January 15, 2025

Mr. Mathew Griffith, AIA  
in situ studio  
704 N. Person Street  
Raleigh, NC 27604

**RE: 2018 NCRC Section R309.2 Carports**

Abbasl House  
6845 West Lake Anne Drive  
Raleigh, NC 27612

02 Longitudinal Section Looking South  
1/4" = 1'-0"

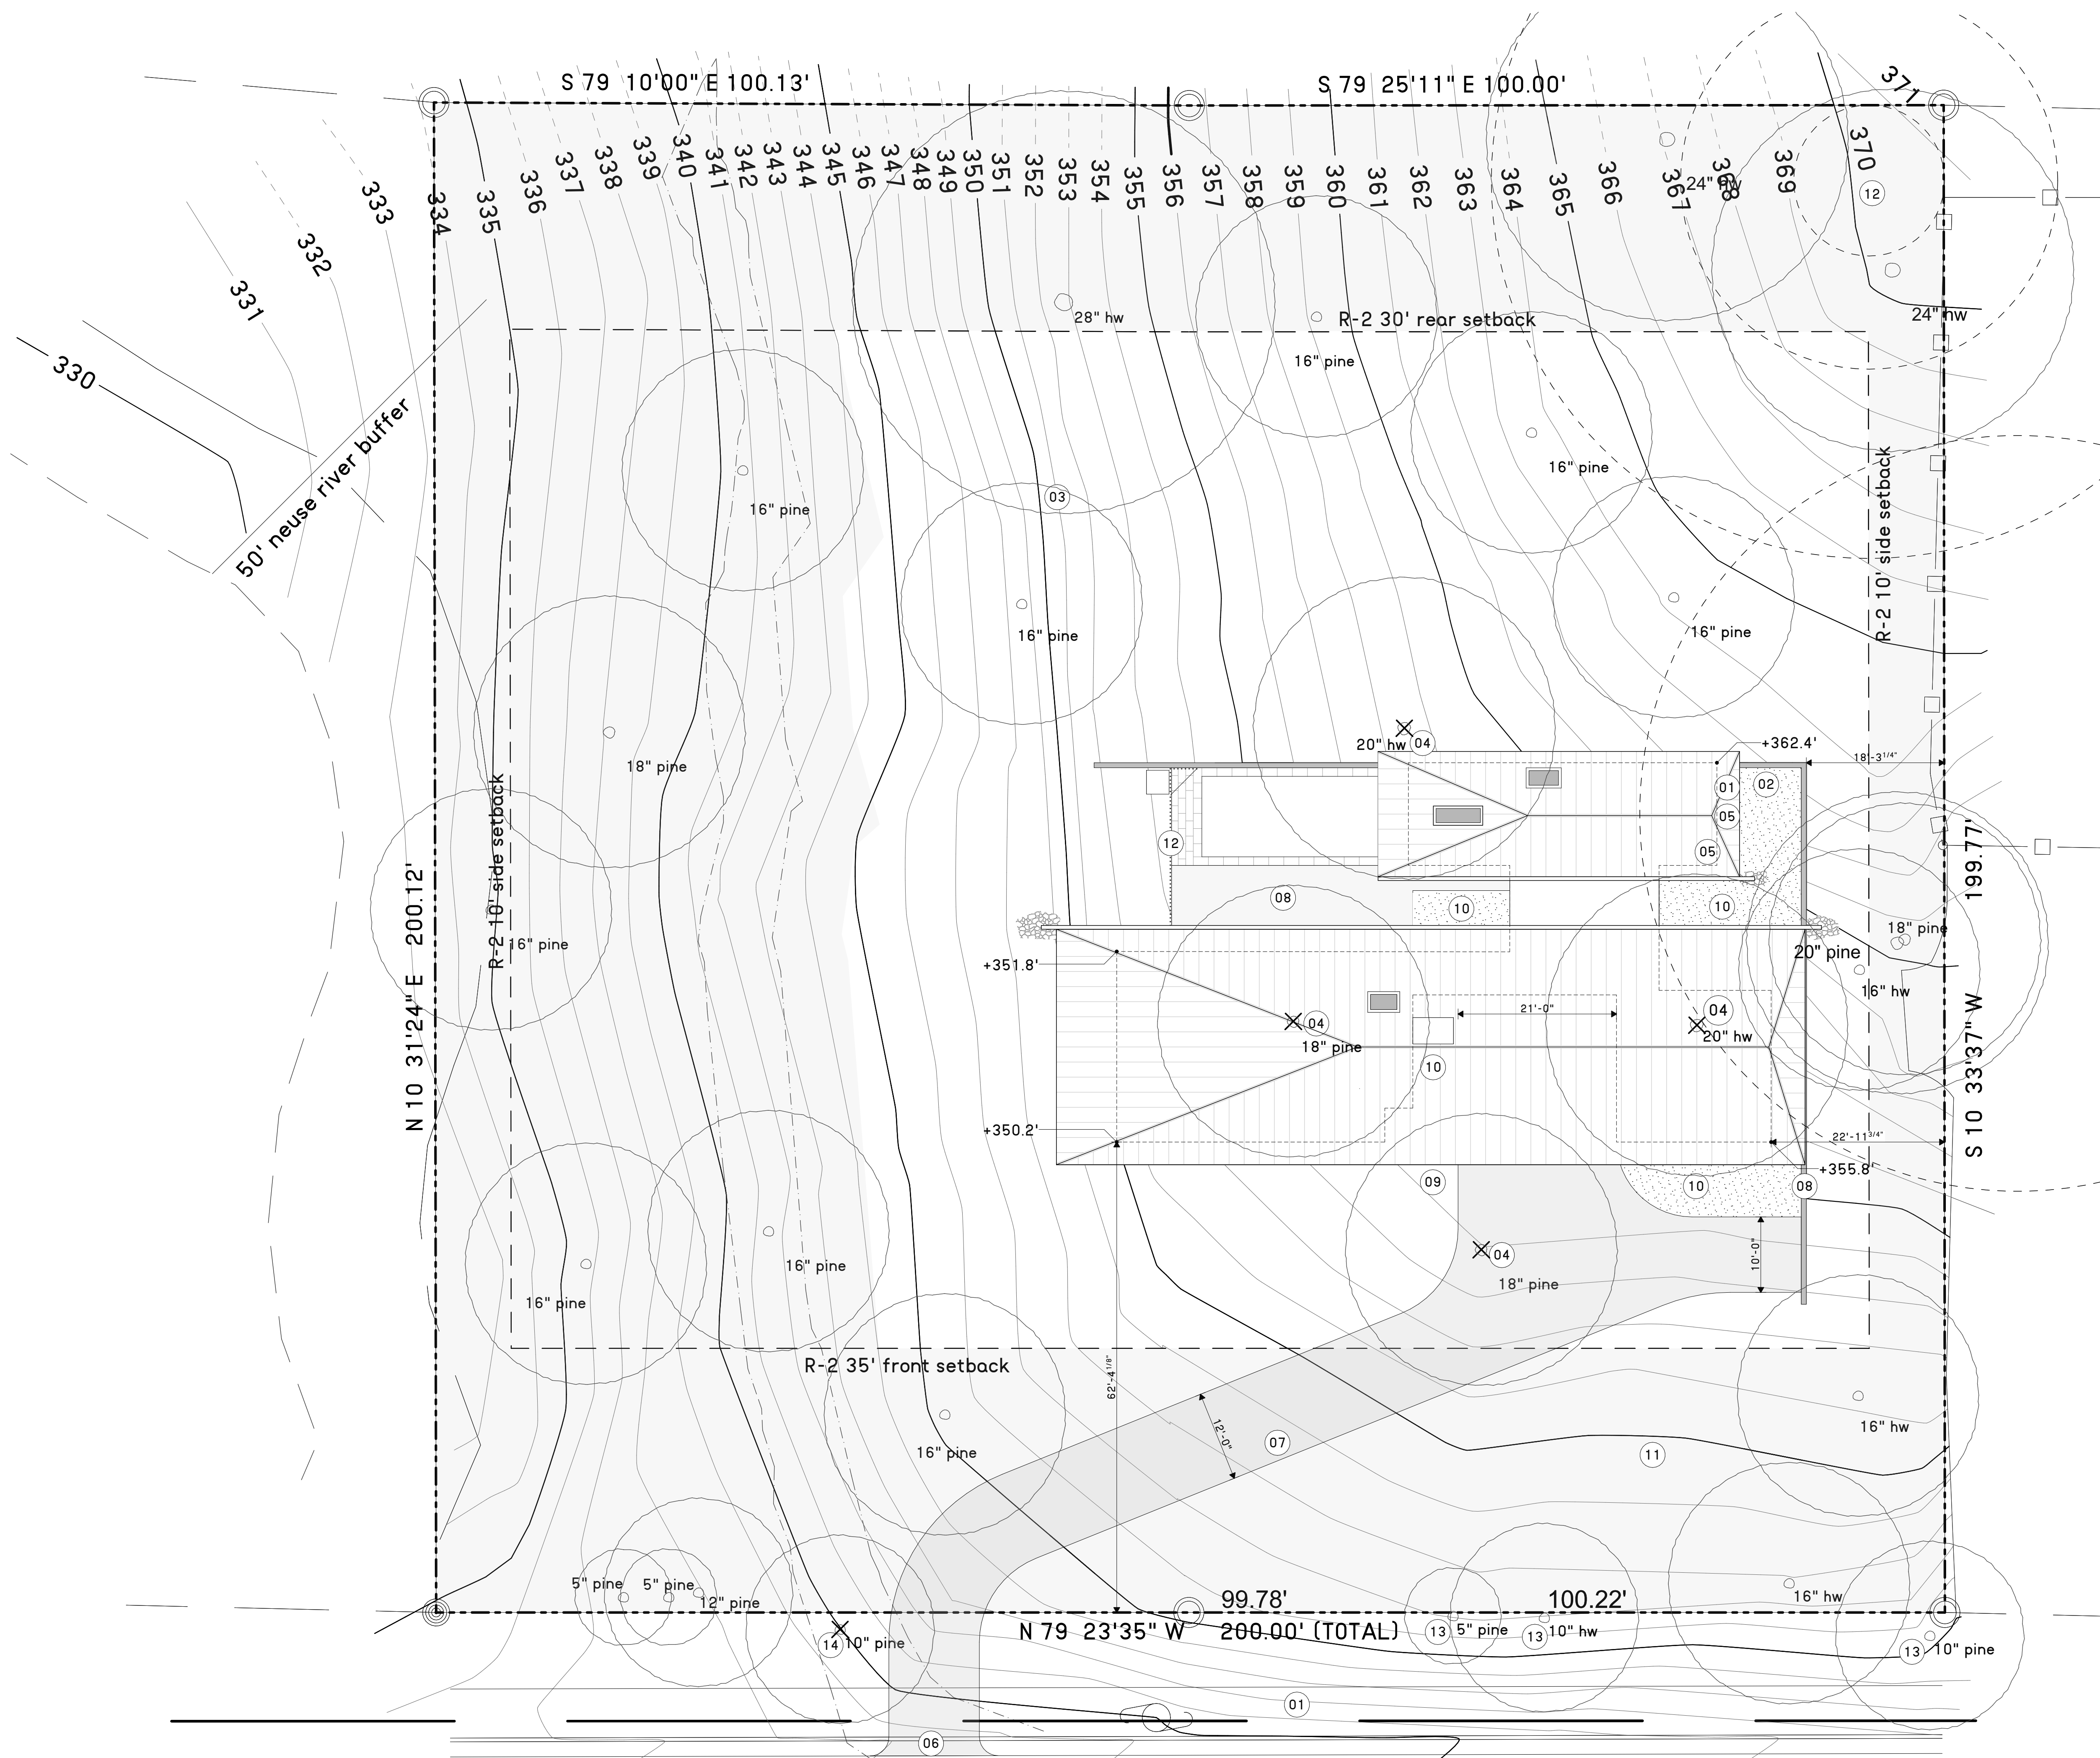
The carport as designed has a 6' wide garden to the left side that is open to the sky by a hole in the roof. It was our intent that this would fill the open requirement.

OPENING THROUGH THE ROOF.

GARDEN.

**Conclusions:** A careful review of the design drawings in Attachment A indicate one open side on the front elevation that extends the entire length of the opening of the space where the parking of automobiles or other vehicles will occur plus the space allocated for the porch, seat wall, garden and private entry. A separate opening to sky is also provided above the garden and seat wall near the private entry. Both the front elevation side opening and the opening to sky do not have any doors.

The code is silent on the configuration of the two open sides required to classify a space used for parking automobiles or other vehicles as a carport. The opening to sky is a separate opening from the front elevation side opening and therefore is considered the second opening required to classify the space called a “carport” in the Attachment A design drawings as a carport in the context in the application of the 2018 North Carolina State Building Code.
